**INITIAL STATEMENT OF REASONS
FOR PROPOSED BUILDING STANDARDS
OF THE STATE FIRE MARSHAL
REGARDING THE 2019 CALIFORNIA BUILDING CODE
CALIFORNIA CODE OF REGULATIONS, TITLE 24, PART 2
(SFM 01/19)**

Example 1

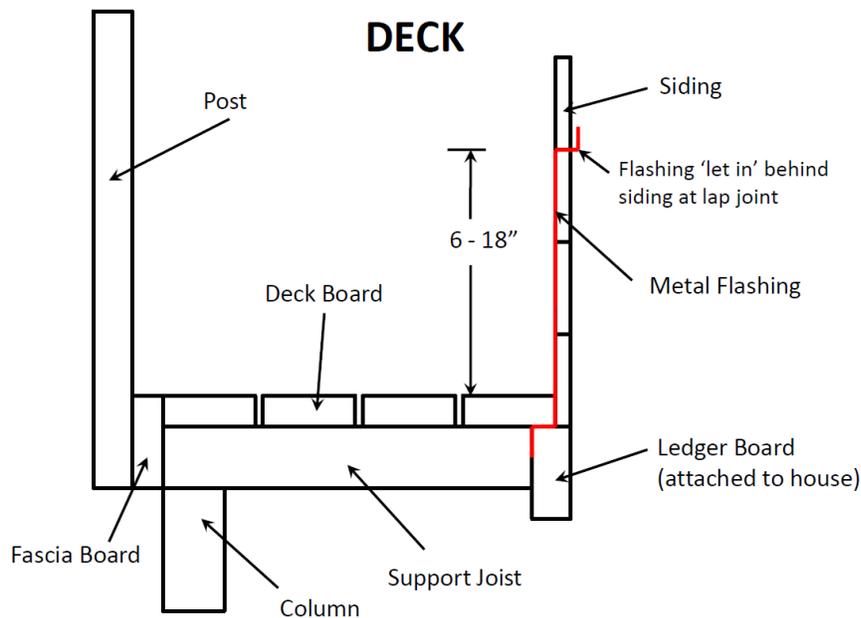
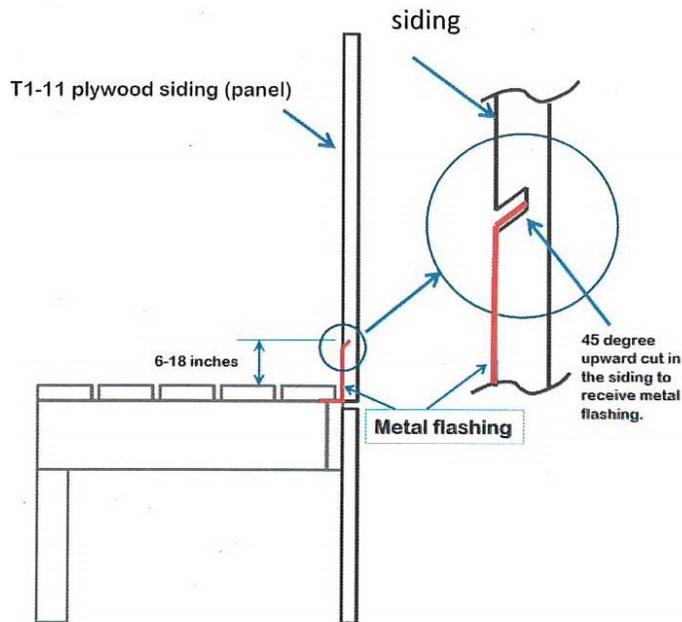
Section 5.6.4 A minimum of 6 in. (150 mm) noncombustible vertical separation between a horizontal surface and siding shall be maintained.

The examples 1 and 2 are show for reference only on to how one may achieve compliance with the code proposal. The code was written as a generic regulation to leave it up to the designer, architect or owner to create a desirable look to meet the intent, which is to prevent the accumulation of debris at the base of the intersection of the exterior wall and deck surface.
